RW CRCRC HEIGHT STUDY

ISSUES

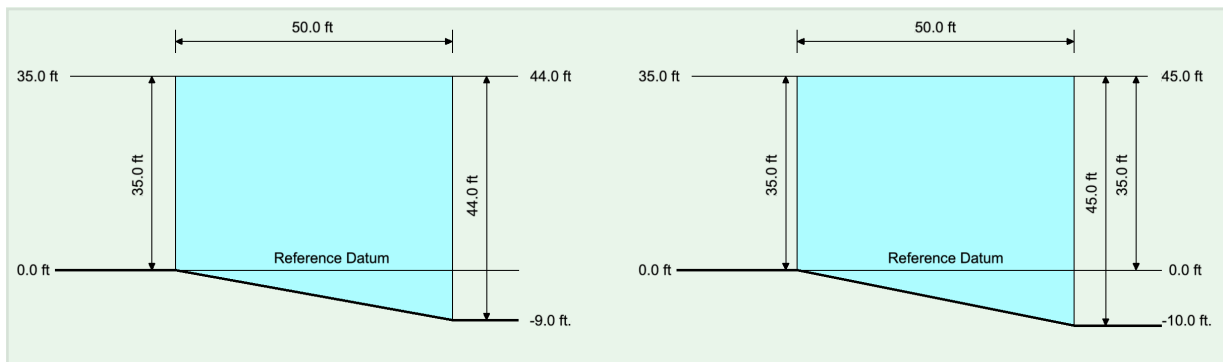
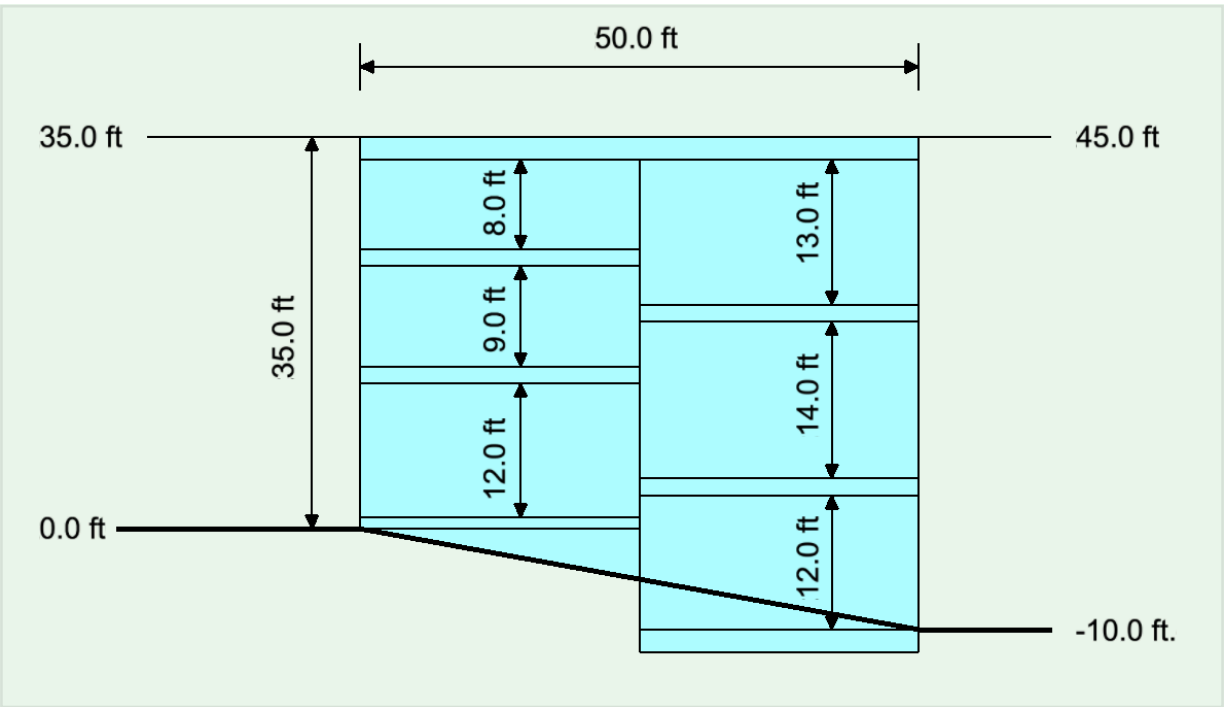
- Sec. 107-71 seems to be in conflict with Sec. 107-3 regarding maximum permissible height. Should we be enforcing maximum building height? Should it overlay the Definitions instead of the other way around?

- The definition of what is an "exterior wall" is unclear - does it include terraces, porches, columns, or must it be conditioned space?
- The newly revised definition of "lowest original native ground surface" could be qualified with, adjoining the exterior wall of the building, for both definitions.

- You can use Def. 1 to build from 35-44ft. depending on slope.
- You can use Def. 2 to build up to 45ft., which can encompass the entire buildable area by grading flat.

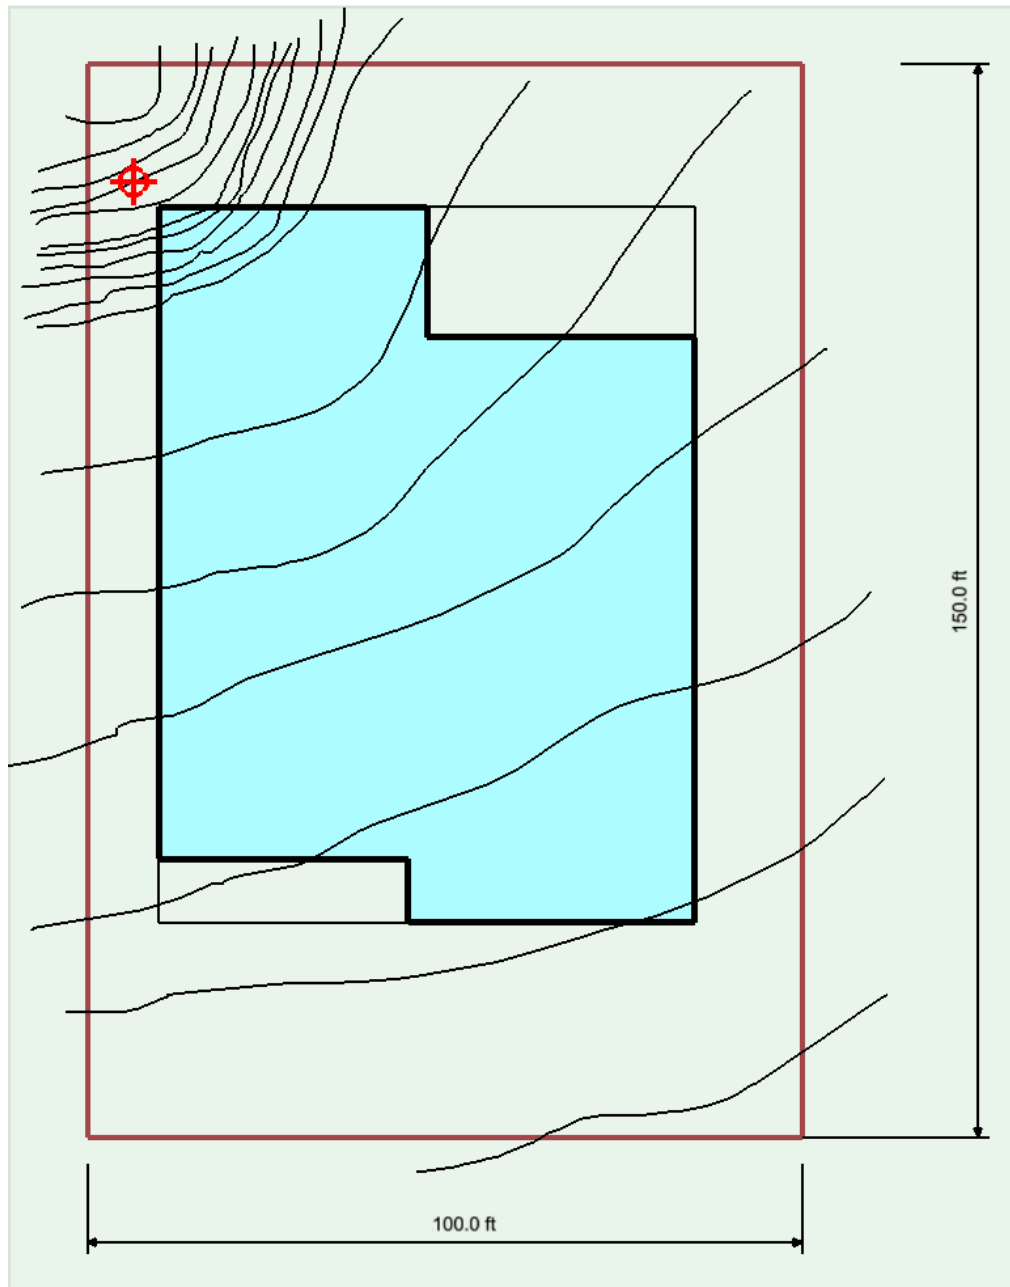
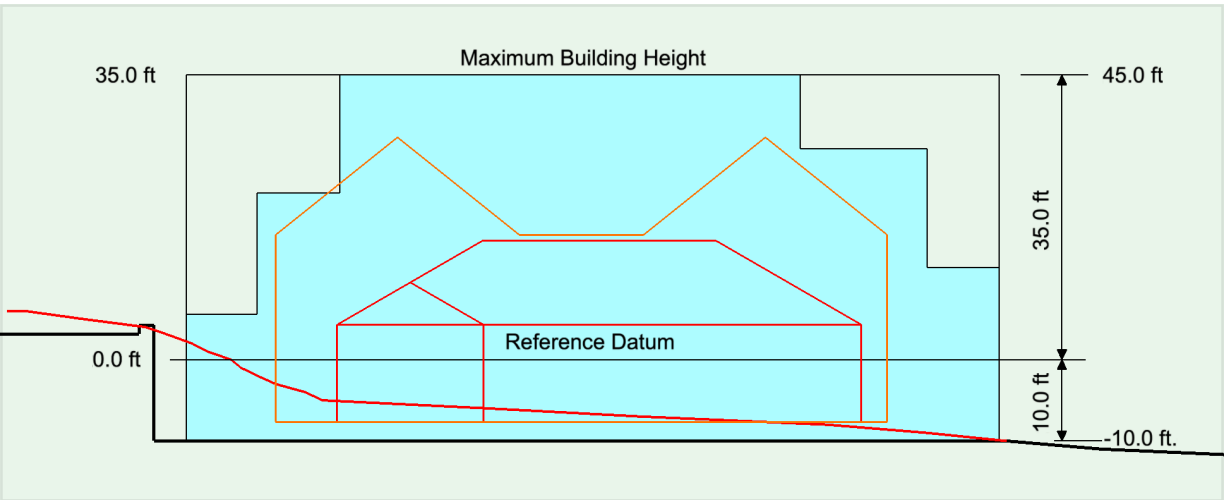
- A property may be generally flat, except for a portion on the perimeter which can allow for greater building height overall.
- This height difference can have implications for neighbors on three sides and across the street.
- Measuring the Reference Datum Point before site development is meaningless if the lot is then graded flat.

- The Reference datum should be the highest survey point before or after construction, whichever measurement is lower.
- A property can build a volumetric 45ft. box, while an adjacent neighbor on a flatter lot at nearly the same elevation can only build a volumetric 35ft. box. Another reason step-function is incompatible with our conditions.

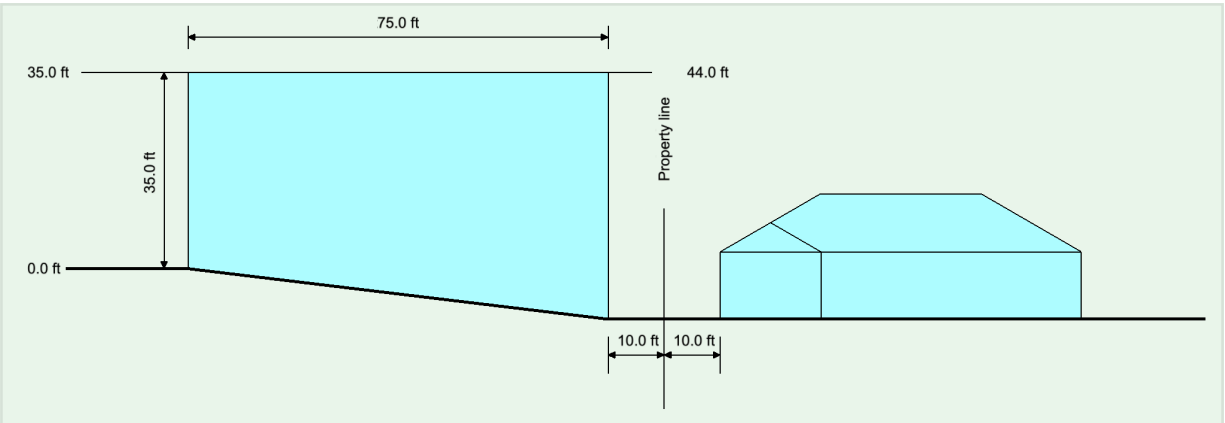
- There is no accounting for **side setback impacts** in our code
- There are no eave height requirements, which allows for a structure that looms over an adjacent property within 20' at a minimum, 30' at a maximum.
- There are a number of recent examples of this in RW.
- Homes can be impacted downslope, as well as upslope.

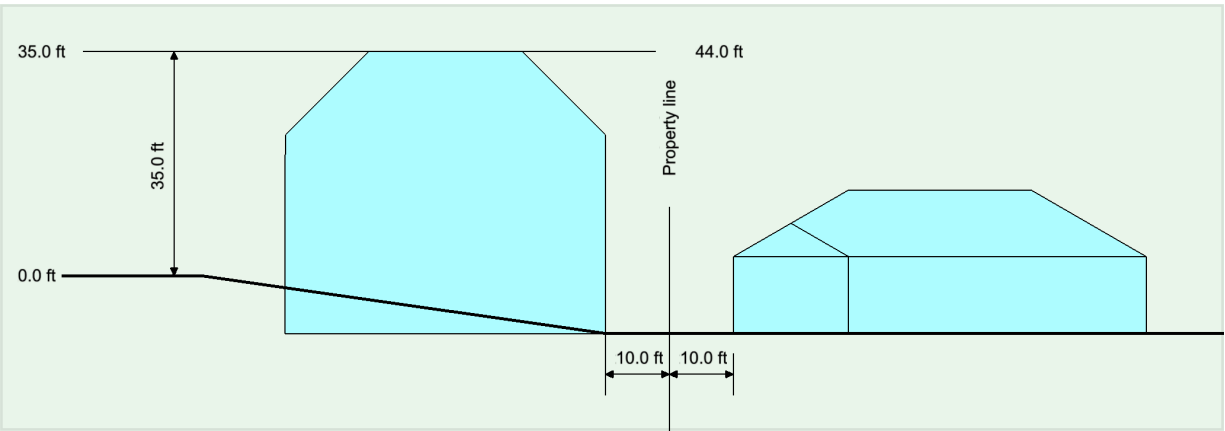
- Helps to mitigate the impact with a sloping roof:

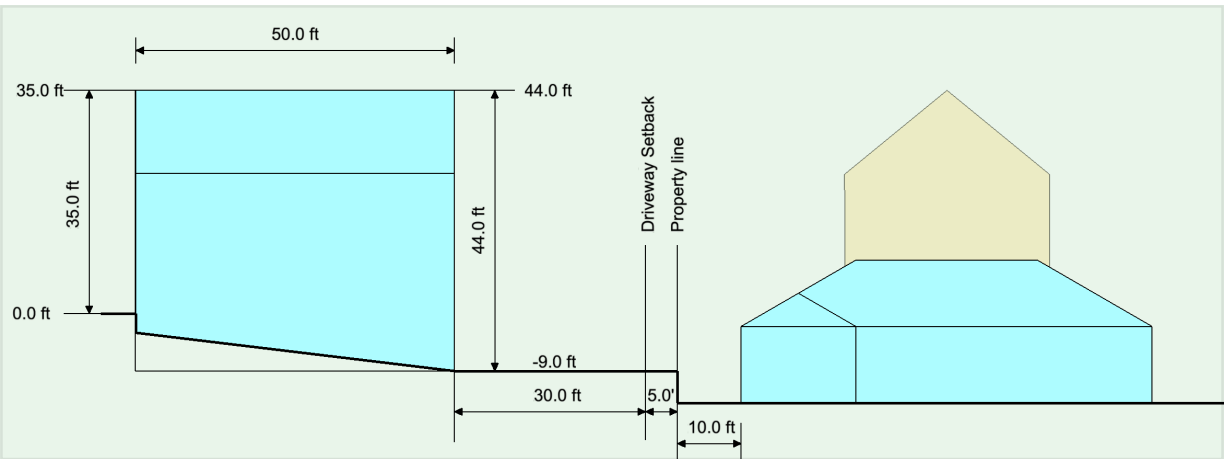
- Homes that have side entry garages reduce the impact by virtue of the 5' driveway setback, plus a minimum of 25-30' backing out distance.
- Also beneficial if the side elevation is narrow, and the highest point is literally a point and not a square or rectangle.

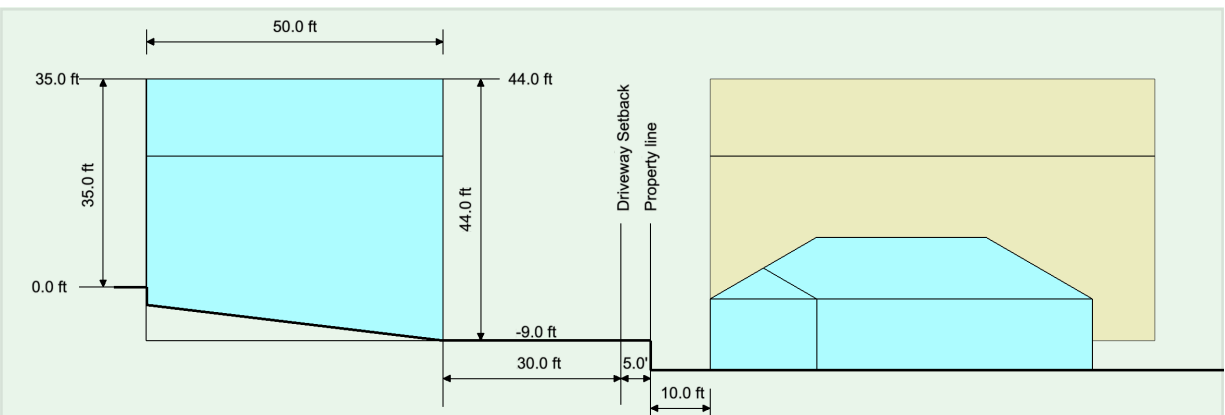
- Starts to feel much different if the volume runs the length of the setback, especially if it is upslope.
- Impacts can also be experienced from across the street, either upslope or downslope, where views were of trees, hillsides, or even downtown, and may impact access to sunlight, but now stare at a large wall of house.

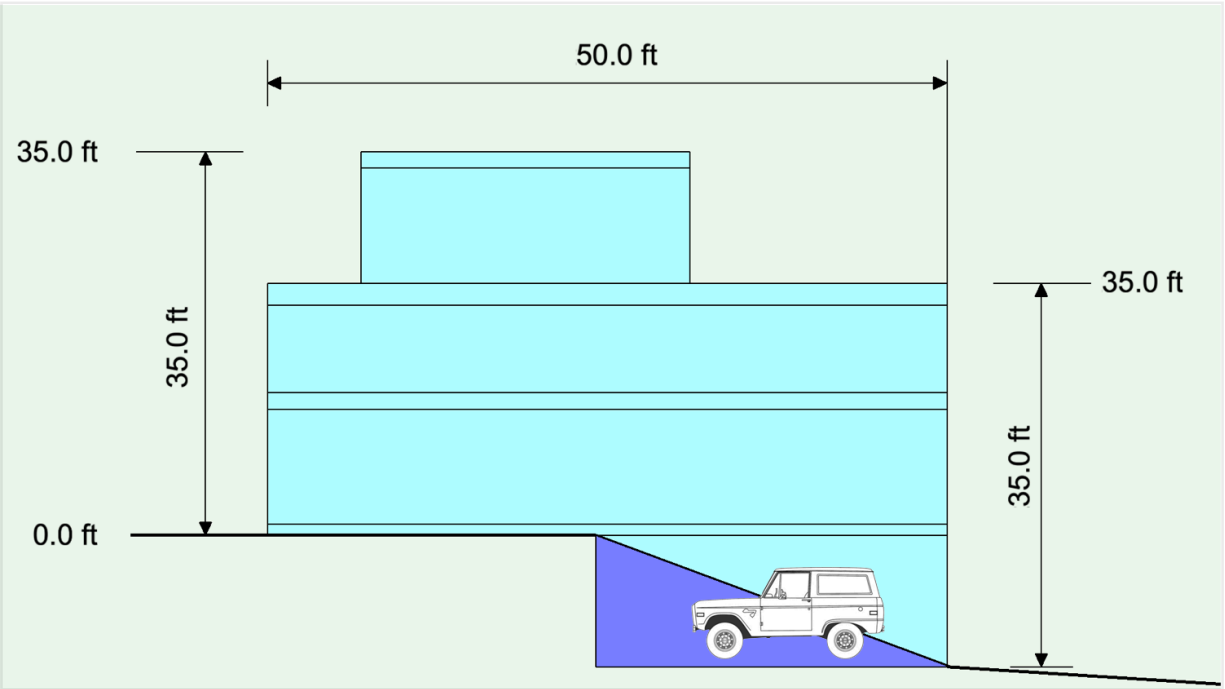
- Homes that have partial basements or garages also reduce visible impacts
- The home below is also an example of Terracing, where no portion of a home exceeds 35ft. above grade.
